**TWRS-P Facility Design Basis Earthquake –
Peak Ground Acceleration, Seismic Response
Spectra, and Seismic Design Approach**

RPT-W375-RU00002, Rev. 1

Rev	Date	Reason for revision	Revised by
0	12/14/1998	Initial Issue	
1	03/17/1999	Revised to incorporate DOE RU comments	Richard Smith

**Figure 3. 200 Area 2,000-Year Return Period Equal Hazard Response Spectra{ TC
"3. 200 Area 2,000-Year Return Period Equal Hazard Response Spectra" \f F }**

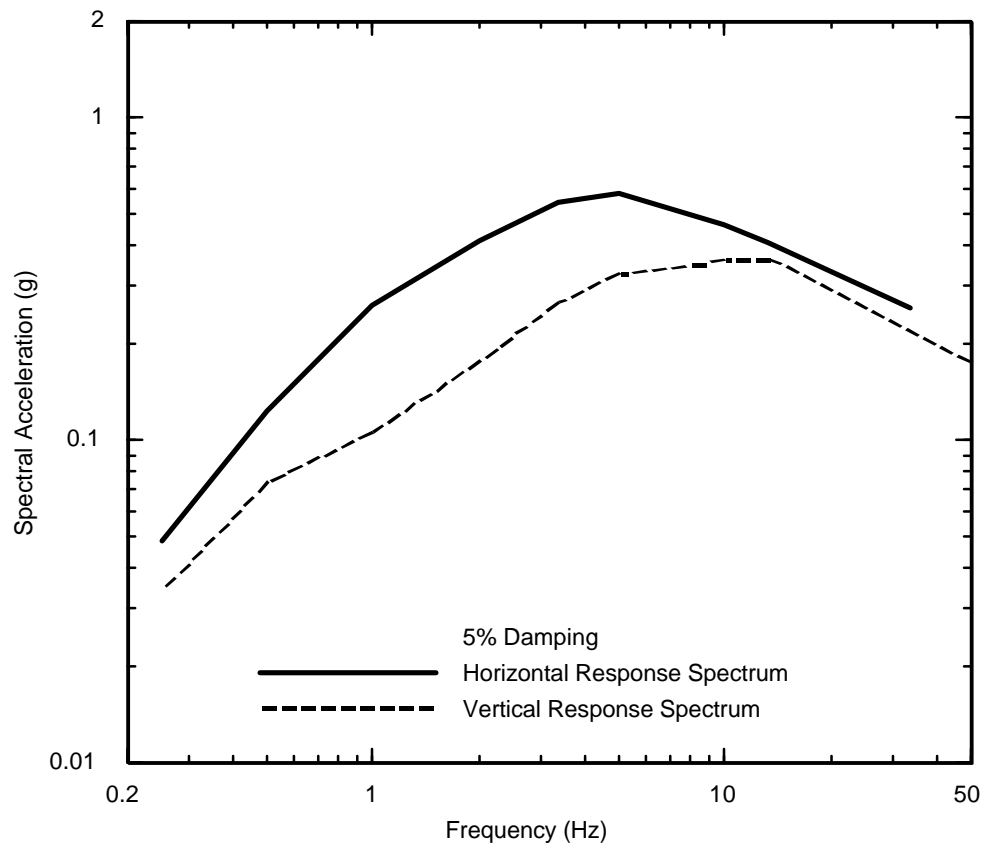
5	Research the availability of recorded site seismic data to compare with Geomatrix Report.	This comment is addressed in the related document <i>Validation of the Geomatrix Hanford Seismic Hazard Report for Use on the TWRS-P Project</i> .
6	Evaluate how the maximum magnitudes in the USGS report (Franker, et al, 1996) compare to the range of magnitudes in the Geomatrix report.	This comment is addressed in the related document <i>Validation of the Geomatrix Hanford Seismic Hazard Report for Use on the TWRS-P Project</i> .
7	Explain “dip” in the vertical response spectra shape.	The development of the response spectra in the Geomatrix report considered the effects from many different faults and seismic settings. The lower frequency portion of the response spectra is strongly influenced by the Cascadia subduction zone and the higher frequency portion is more influenced by nearer seismic events. These two effects, near field and far field, overlap at about the 1 Hz area and result in a small “dip” or concaved area. The union of two effects can result in a concaved zone and be consistent with expected events. In the process of developing design response spectra from the data provided by a seismicity report, however, these concaved areas will be smoothed out, which is conservative.

Figure 3 also shows a “dip” in the vertical response spectra shape. The development of the response spectra in the Geomatrix report (Geomatrix, 1996) considered the effects from many different faults and seismic settings. The lower frequency portion of the response spectra is strongly influenced by the

Cascadia subduction zone and the higher frequency portion is more influenced by nearer seismic events. These two effects, near field and far field, overlap at about the 1 Hz area and result in a small “dip” or concaved area. The union of two effects can result in a concaved zone and be consistent with expected events. In the process of developing design response spectra from the data provided by a seismicity report, however, these concaved areas will be smoothed out, which is conservative.
